CITY OF SANTA BARBARA

COUNCIL AGENDA REPORT

SUBJECT: Appeal Of Architectural Board Of Review Project Design Approval Of A New Seven-Unit Apartment Building At 1818 Castillo Street

Site Plan Comparison

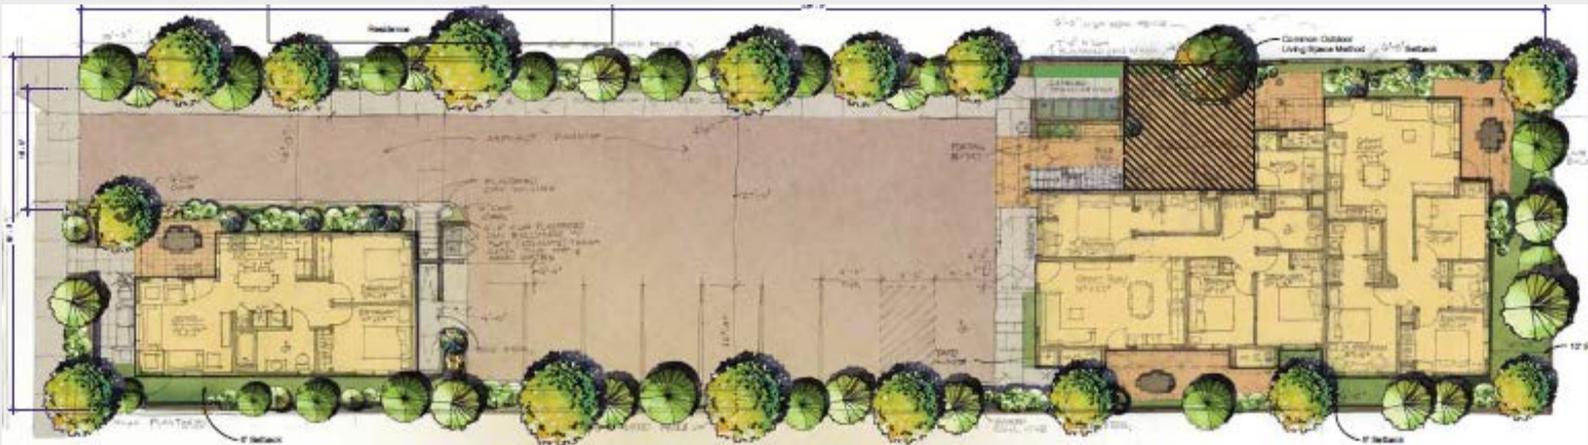
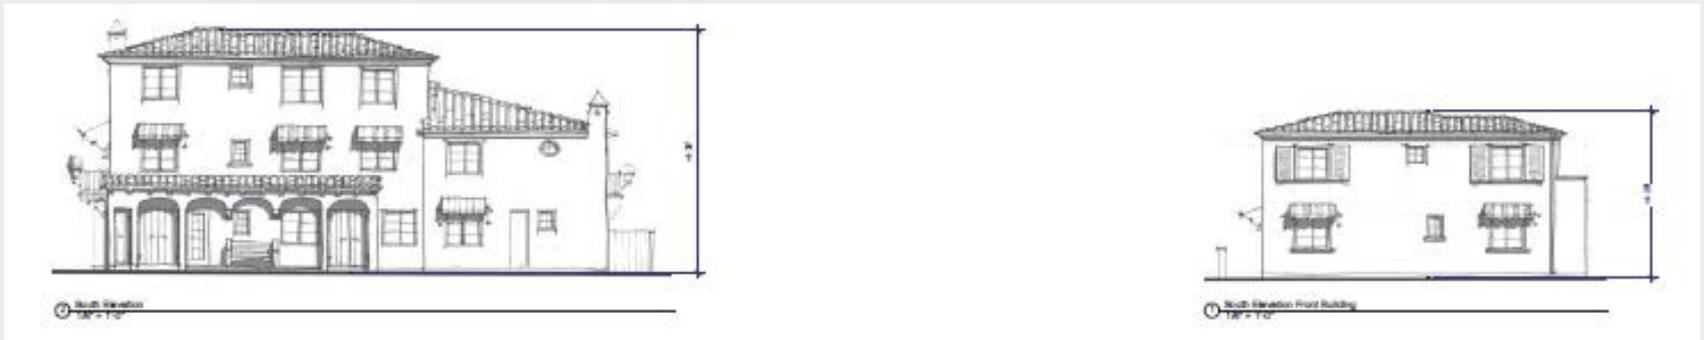
- 11/9/15 – ABR conceptually reviewed revised project
 - ABR review:
 - *Revised project “vastly” improved*
 - *Massing and design layout successful*
 - *Compatible with neighborhood*
- 1/4/16 – ABR granted Project Design Approval
 - ABR review:
 - *Lot area covered by building reduced*
 - *Size, bulk and scale reduced*
 - *3rd story centrally located, impact to neighbors reduced*
 - *Compatibility Criteria Findings made*
